The Width of the Receiving Pool Wall

Restoring the 420mm Pool Depth and Resulting Wave Effects

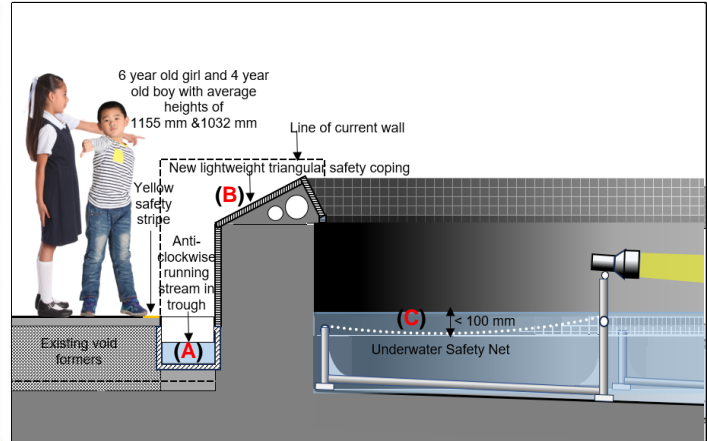
Current wide flat coping on low pool wall

Encourages children to climb onto, sit and stand on rim - increases risk of small children falling into new deeper water and invites others to paddle in pool.

Water depth above 100mm not considered safe.

Three Possible Safety Measures

- A) Restore original thinner wall width & form shallow stream around base**
Provides barrier & distracting safe water feature for small children
- B) Replace flat coping with triangular safety coping**
Stops people from sitting, standing or walking on rim of pool
- C) Install a freestanding underwater safety net**
Catches small children still falling in & prevents paddling in pool

Plan of fountain complex, showing all 3 possible safety measures

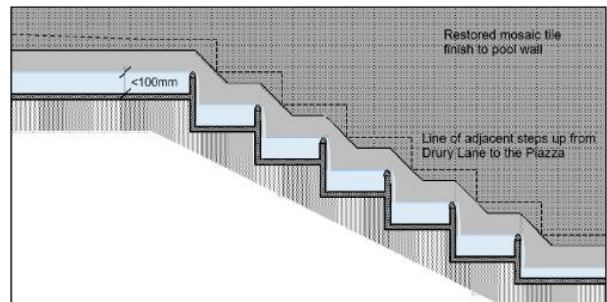
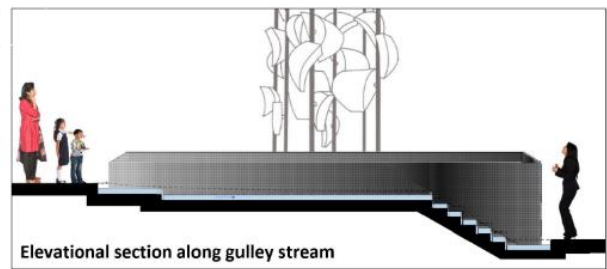
Reducing the wall width by nearly a half also provides the opportunity to introduce a third layer of safety on top of the proposed installation of a triangular safety wall coping and a safety net 100mm or less under the water surface. With the LCC providing no advice whatsoever on the health and safety requirements needed to compensate for the proposed significantly increased pool depth and there also being little or no official guidance available from HSE or others on this issue, minimising the possible risk of a small child drowning in the deeper water is no insignificant thing, even if this is seen as somewhat of a belt and braces approach.

While I do not disagree with Clancy Consulting's conclusions, these appear to have been based on a professionally informed hunch rather than actually on any true structural survey investigating the dimensions of the structure or involving a careful calculation of the imposed loads. Consequently, clearly reducing the imposed loads to directly compensate for the increased weight of water by reducing the width of the wall would again be to err on the safe side.

The gulley stream would catch any water splashing over the pool on the rare but entirely possible occasion when more than 3 hoppers tip simultaneously to produce exceptionally high waves. To avoid the gulley stream from overflowing due to additional wave water or just rain, there would be a simple overflow at the lower level connected to the adjacent street drains.
